APPLICATION FOR ZONING CHANGE

Date 2-25-91NAME OF PROPOSED DEVELOPMENT Steger Retail AdditionLOCATION OF PROPOSED DEVELOPMENT N.E. corner of FM 740 and  
FM 3097NAME OF PROPERTY OWNER/DEVELOPER Estate of O.L. Steger, Jr. and Emily Sue  
Whitehead  
c/o Lakeside National BankADDRESS P.O. Box 9PHONE (214) 771-8311Rockwall, Texas 75087NAME OF LAND PLANNER/ENGINEER Winkelmann & Associates, Inc.ADDRESS 12800 Hillcrest Road, Suite 200PHONE (214) 490-7090Dallas, Texas 75230TOTAL ACREAGE 4±CURRENT ZONING ANUMBER OF LOTS/UNITS 1PROPOSED USE FOR DEVELOPMENT Grocery Store

FOOD LION, INC. SITE #50a  
F.M. 740 @ F.M. 3097  
Rockwall County  
Rockwall, Texas

I have reviewed the preliminary information that has been submitted in conjunction with this request. Additionally, the Planning and Zoning Commission reviewed the plans in their last worksession and our comments regarding the proposed development are as follows:

JOB NO.	06416.01
DATE	2-18-91
DRAWN	A.J.L./A.L.C.
CHK.	M.D.C.
DISC.	6416Site.Dwg
SHEET	1 of 1
OF	
LANDSCAPE PLAN

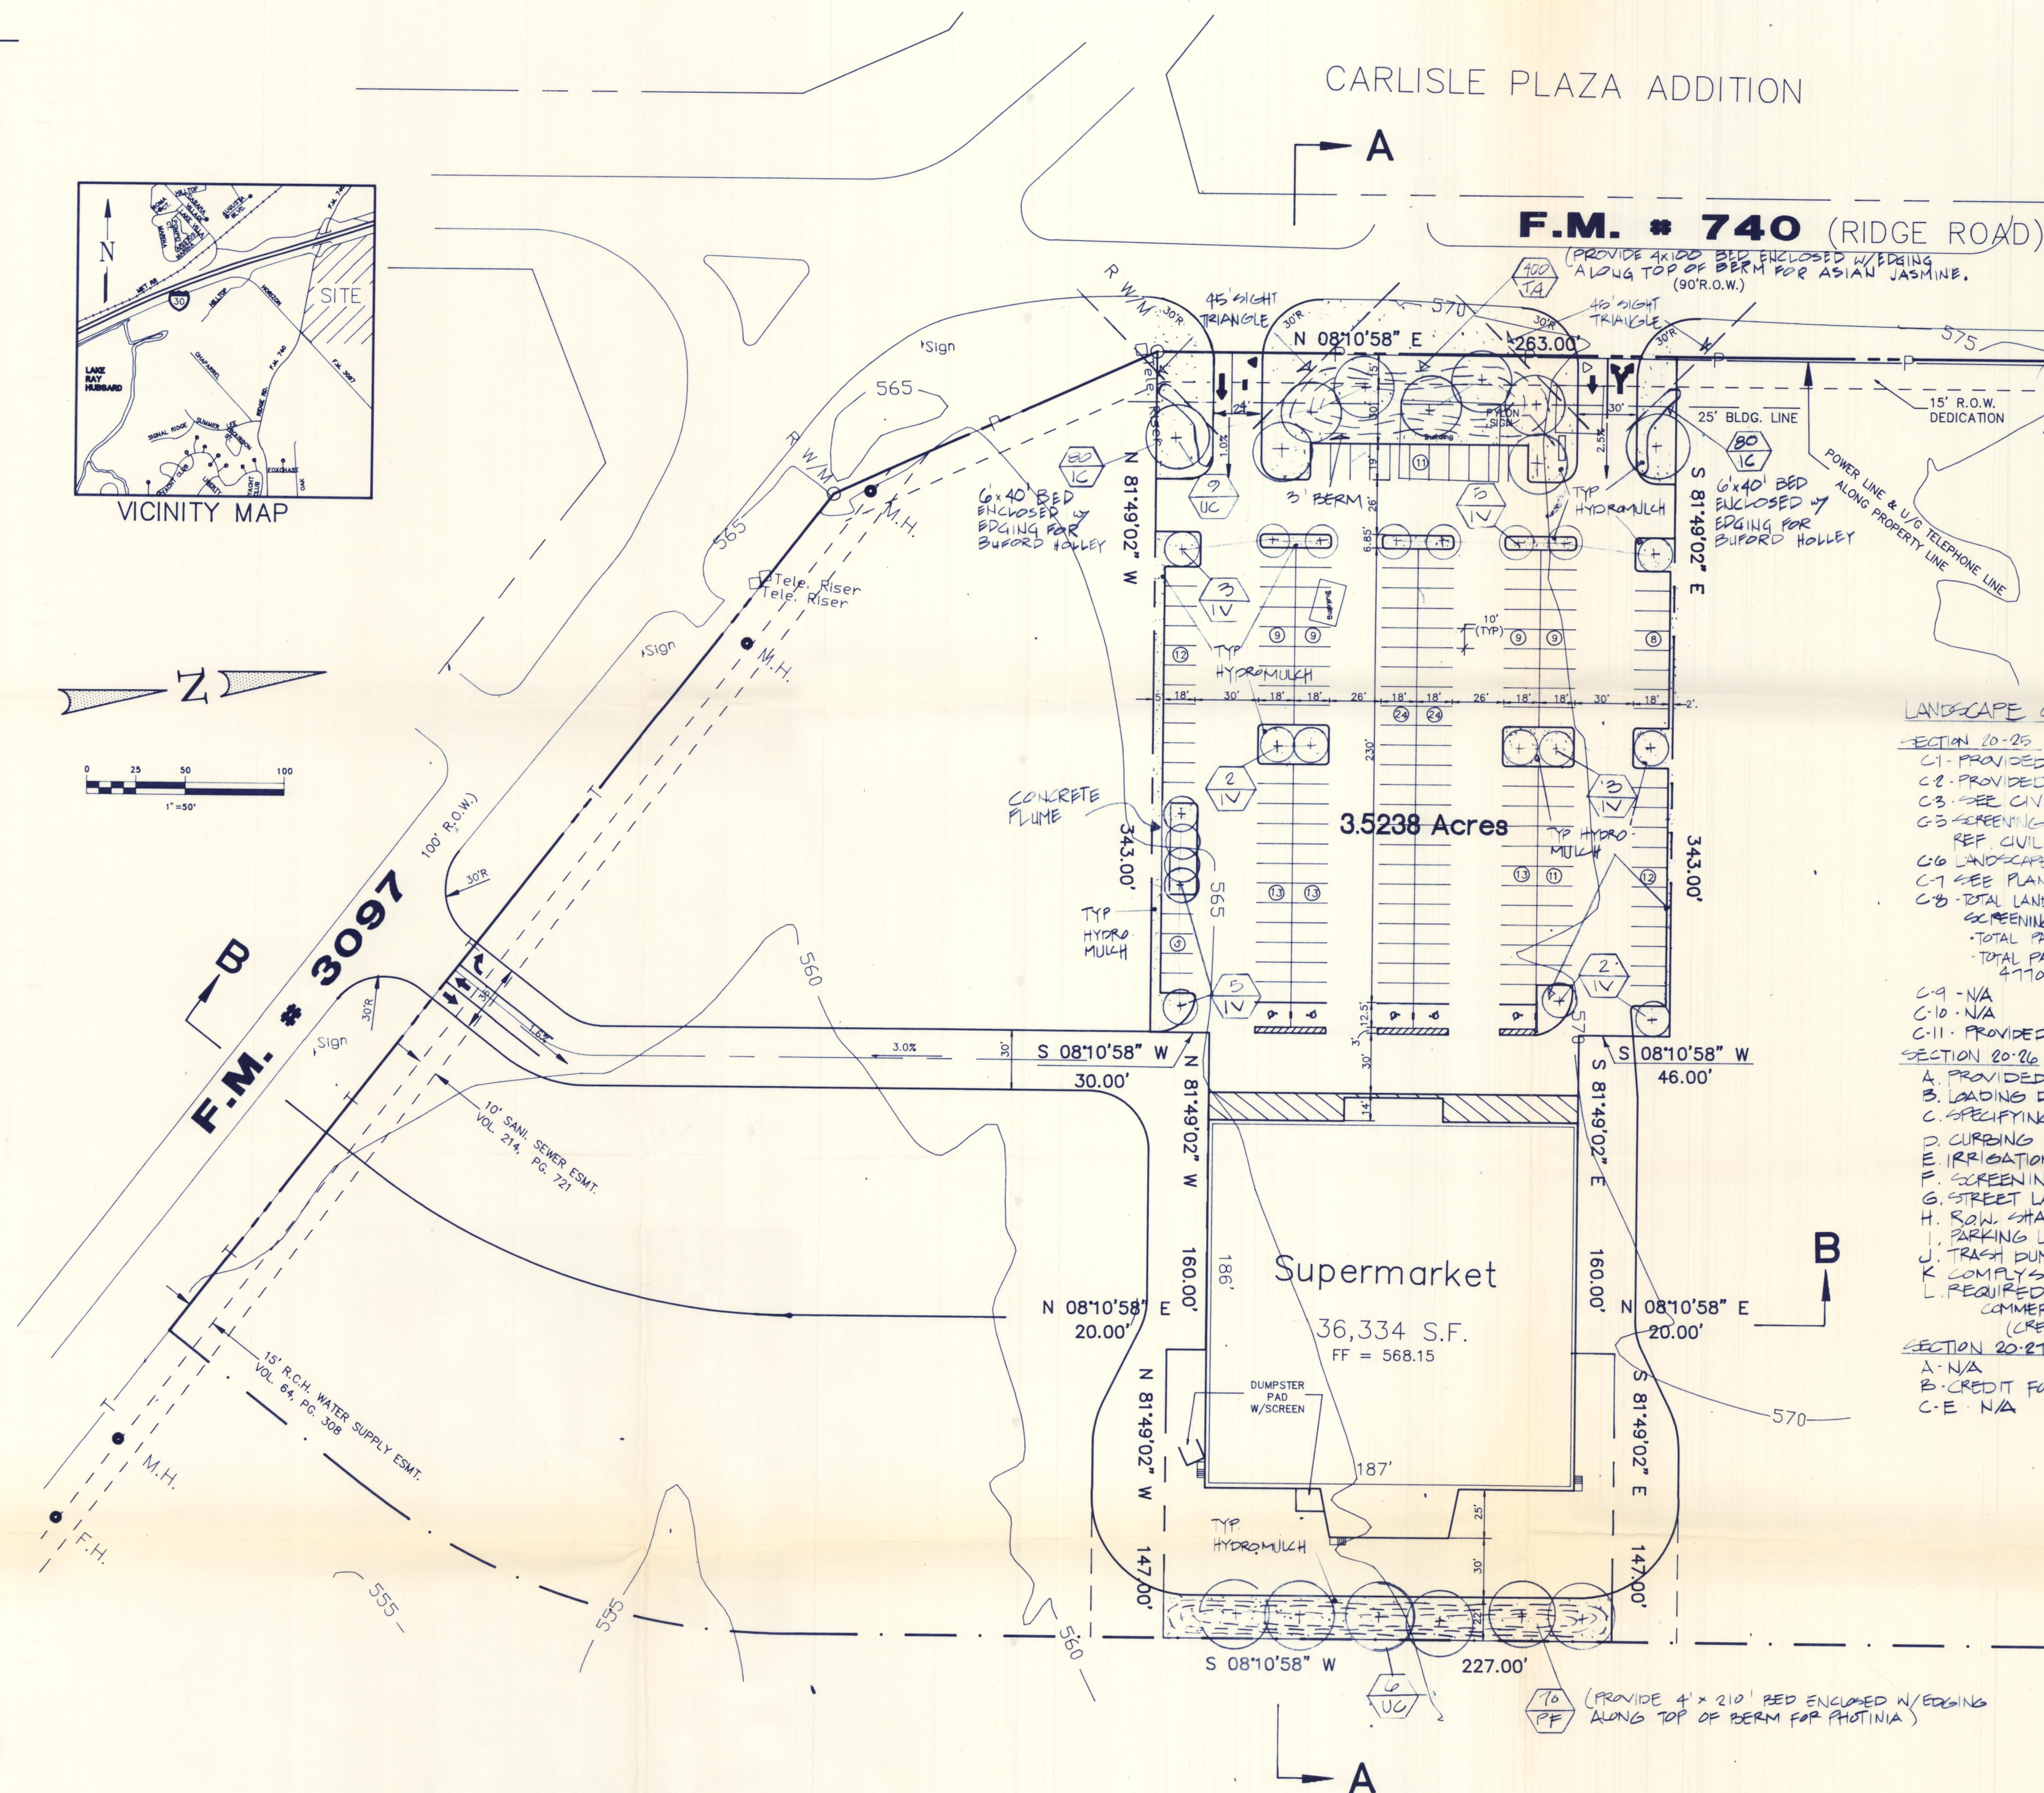
1. The total site requirement for landscaping is 18,708 sq. ft. In reviewing the plan I find approximately 16,600 sq. ft. Please identify the area of the individual landscaped areas. The area to be dedicated as ROW for FM-740 cannot be included in the calculation. I would recommend that you consider including an 8 foot strip between the two center parking stalls. This would provide the additional landscaping area and would enhance the parking lot.
2. You have reduced the percentage of required landscaping by including a 3 ft. berm in the front of the tract. Please identify what landscaping will be planted on

the berm in addition to the required street trees. I would encourage some low maintenance ground cover or low shrubs along the top of the berm. You will need to add 3 foot evergreen shrubs in front of the parking lot on either side of each entrance to fully gain this credit.

4. You need to add 2 more trees along the frontage. In the Overlay District the ratio is one tree per each 30 feet of frontage.
5. You are showing 17 yaupon holly trees internal to the parking lot. These are classified as small trees under our landscaping ordinance. The ordinance provides that one large tree per every 20 parking spaces be provided. This may be considered an equivalent exchange by the Commission, which will be discussion at the meeting.

JOB NO.	06416.01
DATE	2-18-91
DRAWN	A.J.L./A.L.C.
CHK.	M.D.C.
DISC.	6416Site.Dwg
SHEET OF	1 of 1
SITE PLAN

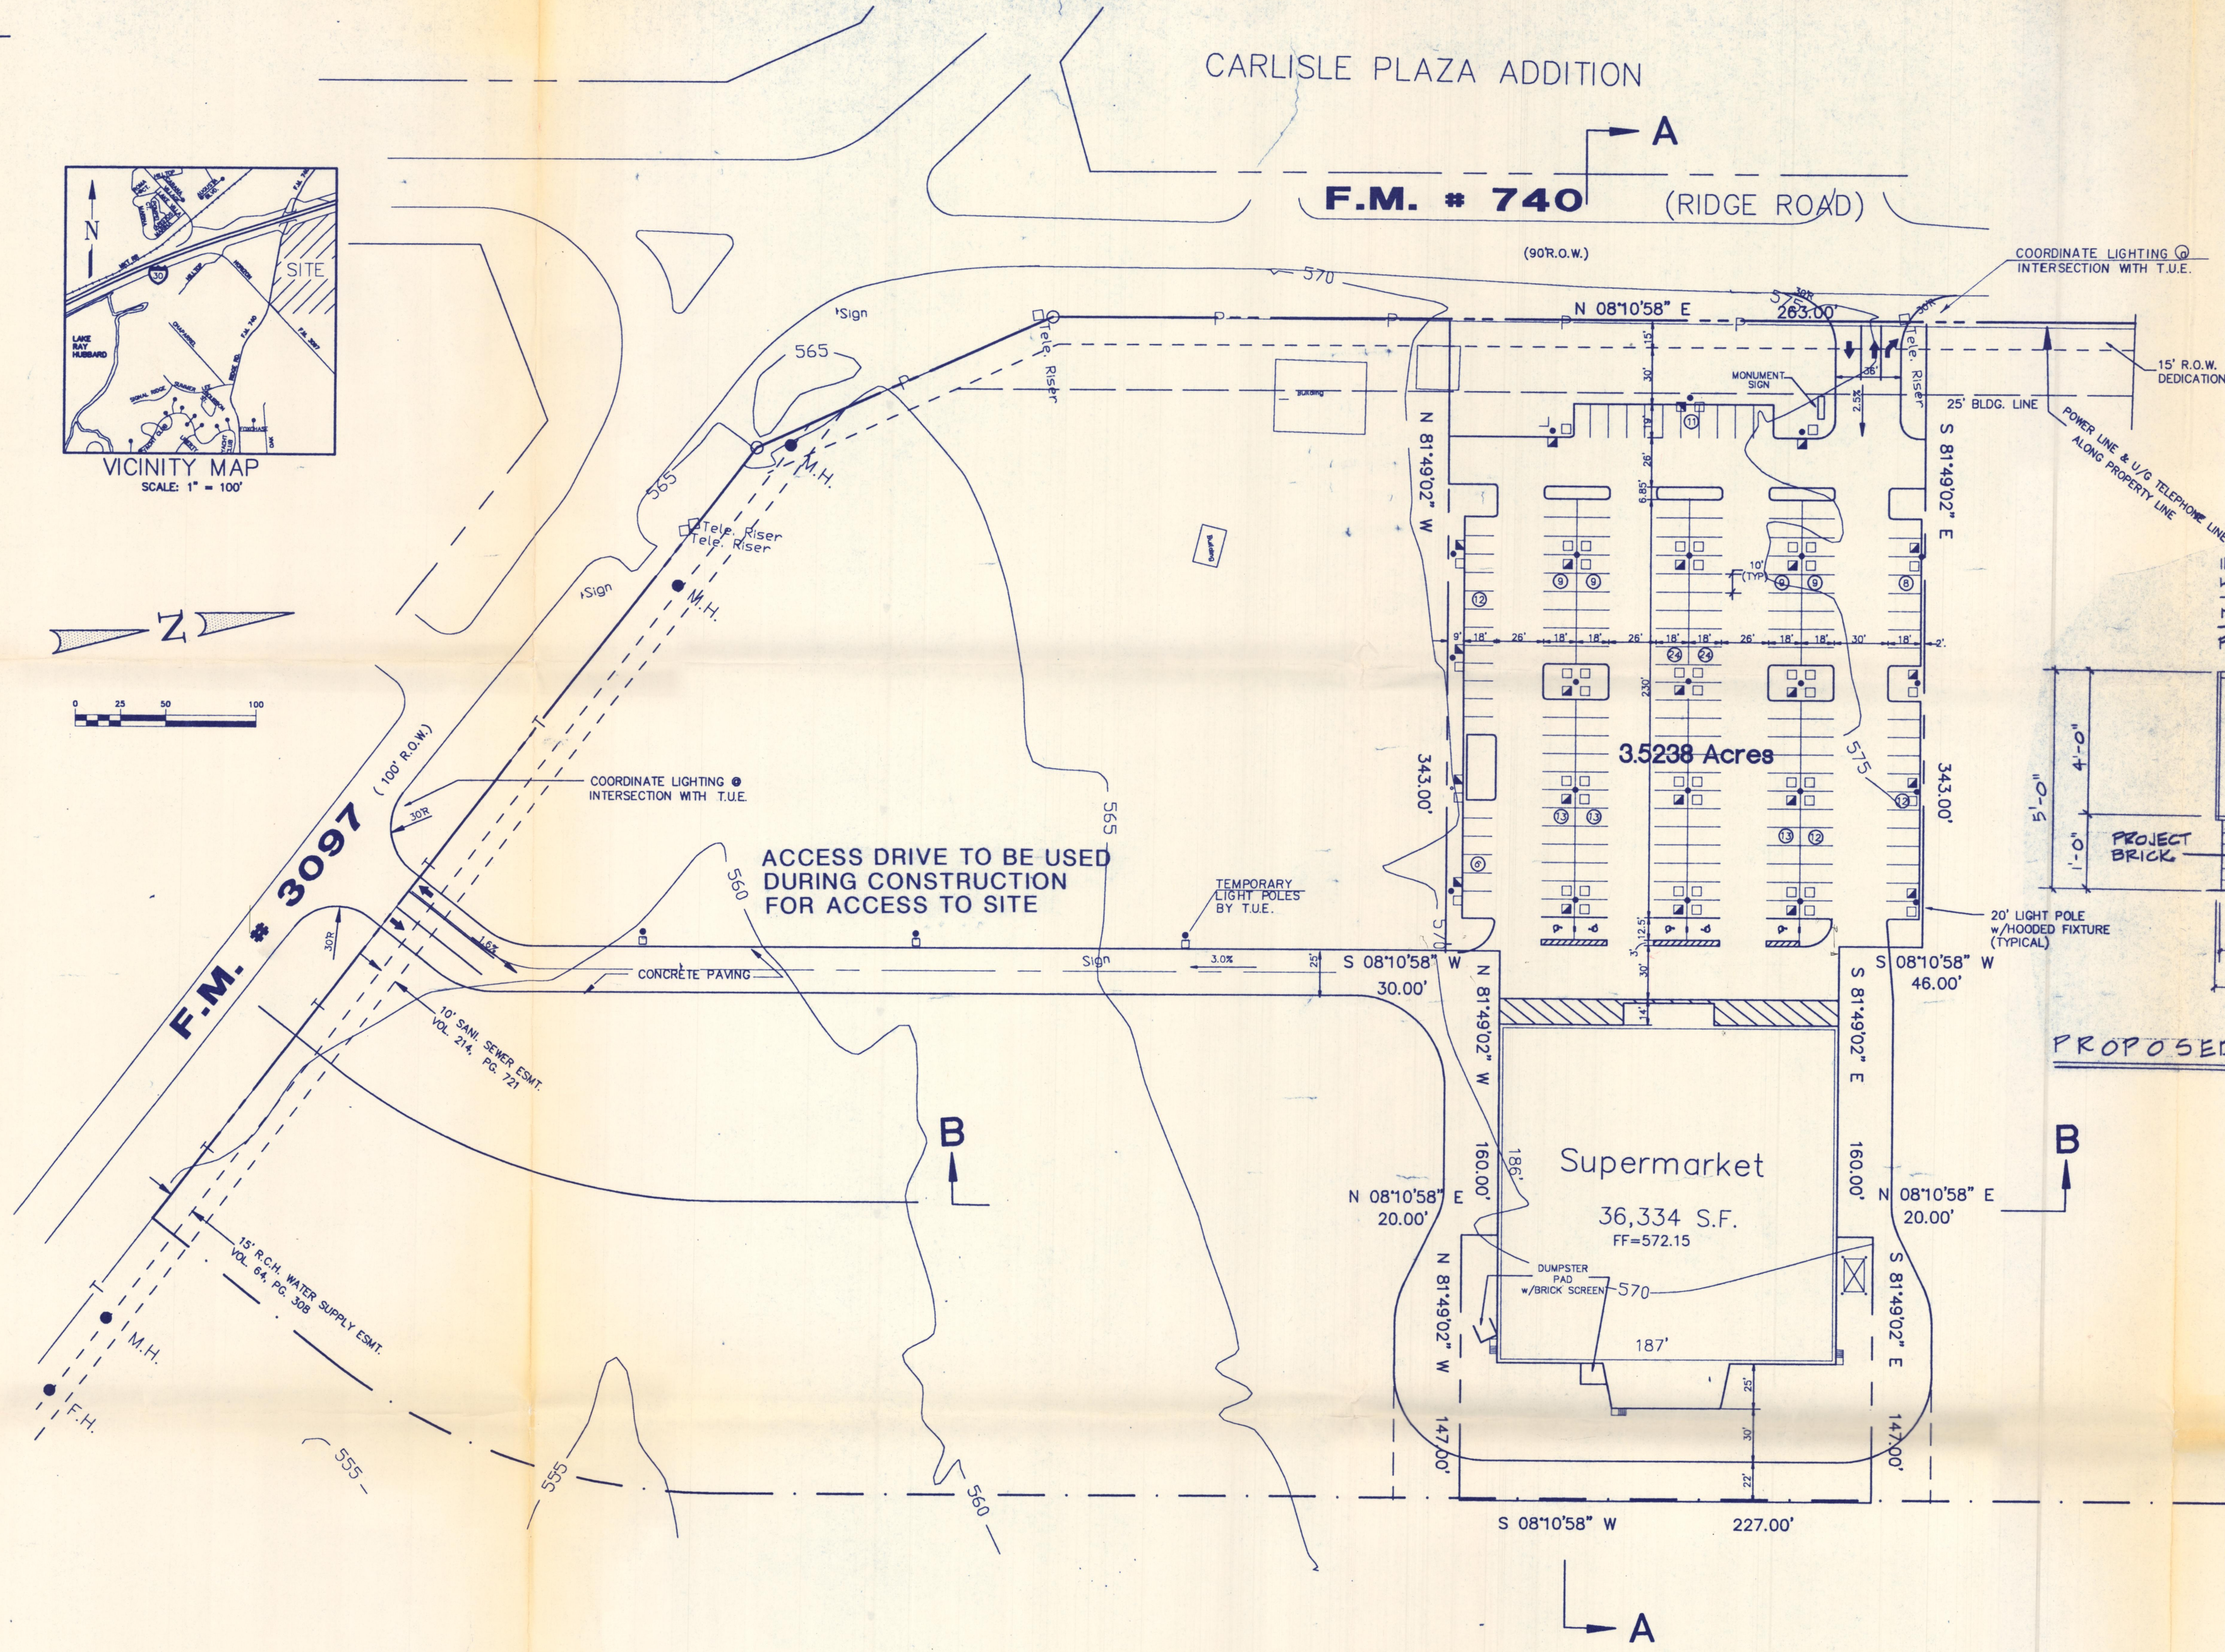
*Approved copy*  
*need to change landscaping*

1. The plan proposes two drives on FM-740 that are approximately 160 feet apart. The minimum separation for drives along an arterial is 200 feet. The Commission

and Council have the ability to waive this requirement if it is determined to be in the interest of the City. The Commission and staff have some concern about the proximity of the southern drive to FM-3097. Given this concern and the fact that the drives do not meet separation standards you will need to either amend the plan to eliminate the southern drive or present your reasons for wanting the two drives. The original plan proposed for Food Lion to the south of this location did not propose two drives on FM-740.

3. There was some concern about the throat length of the entrance(s). I am having John Reglin review this issue.
4. As you are aware a turn lane does need to be provided for the entrance off of FM-740. From preliminary discussions with Mr. Reglin it appears that the existing turn lane for the shopping center can be added onto to meet the needs of your turn lane. You need to submit a schematic of what you propose to do to address the turn lane.

5. You need to submit details for the parking lot lighting. The previous site plan was restricted to light poles not exceeding 20 feet in height with hooded fixtures to direct the glare. Please indicate the type and height of lighting proposed.
